UPDATED					
Jan 1 19:50:40 2016					
DRAWN					
CHECKED		dffs			
CHECKED	SIZE CAGE NO.	DWG NO.			REV
ISSUED	SCALE		SHEET	OF

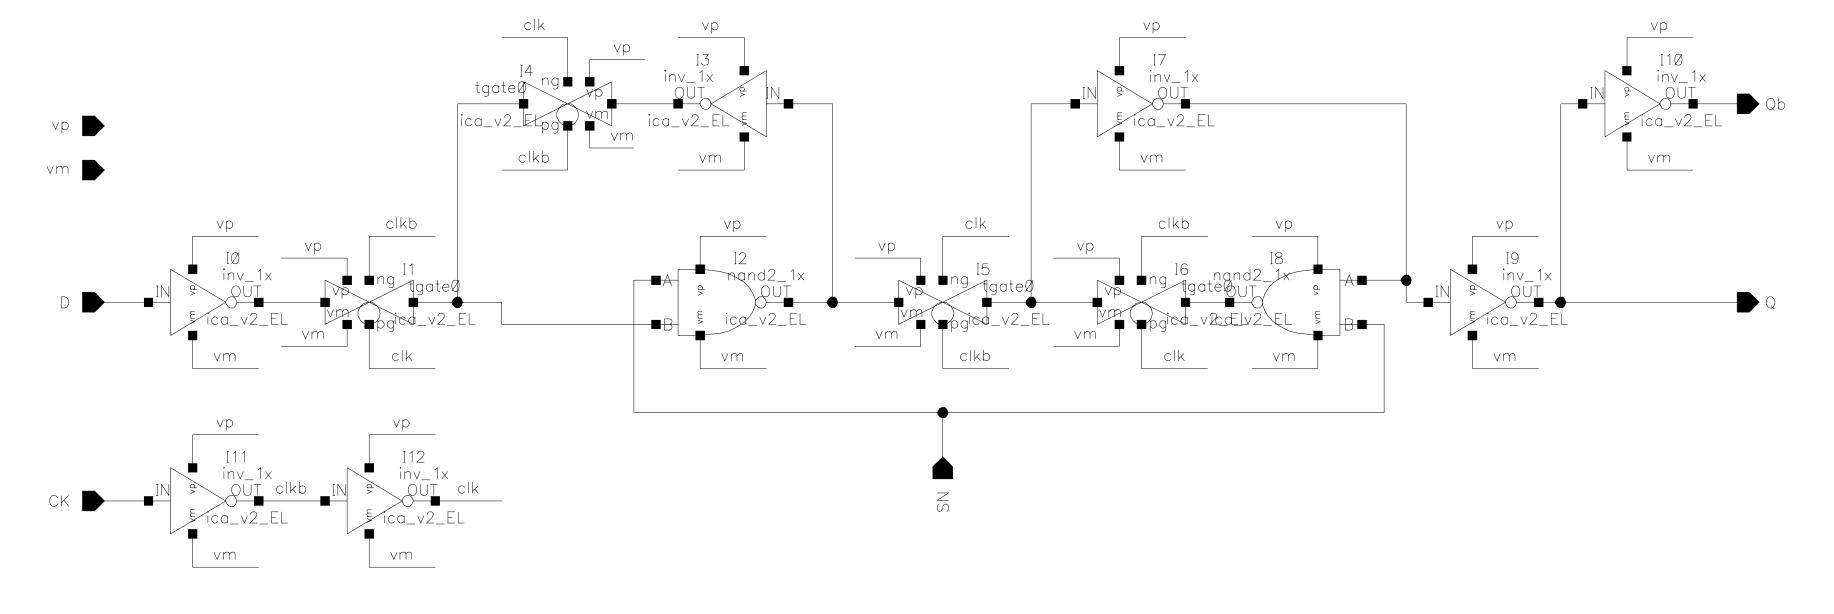
## Asynchronous RN sets Q=logic "1" NEED clock to be HIGH TO hold this value!!

Flip tgateØ I4 sideways for LVS
